**Consultation Response from KC,
Trees**

2025/91531 land off, Leeds Road, Heckmondwike, WF16 9DB

Demolition of existing semi-detached houses and associated buildings, and construction of 51 dwellings, including associated access and other associated works

Date Responded: 14/08/2025

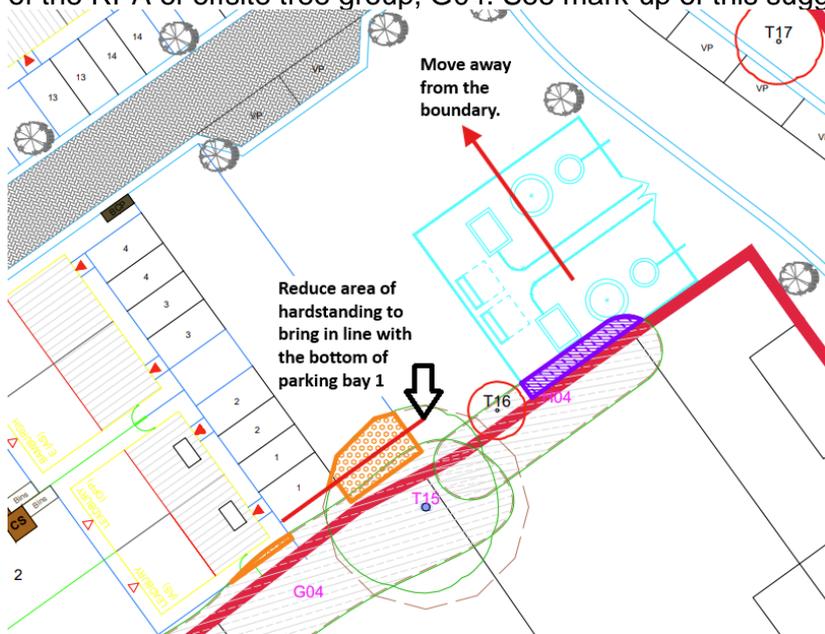
The RPA and canopy of offsite, Cat B T15 is also incurred by the proposals. The crown clearance on the north side is recorded at 1.5m and the canopy extends northward for 6 to 7m. Here too, some amendment is required. For example, the area of hardstanding beneath the tree could be reduced to bring it in line with the first parking bay of proposed plot 1. This would also bring the hardstanding out of the RPA of offsite tree group, G04. See mark-up of this suggestion below:
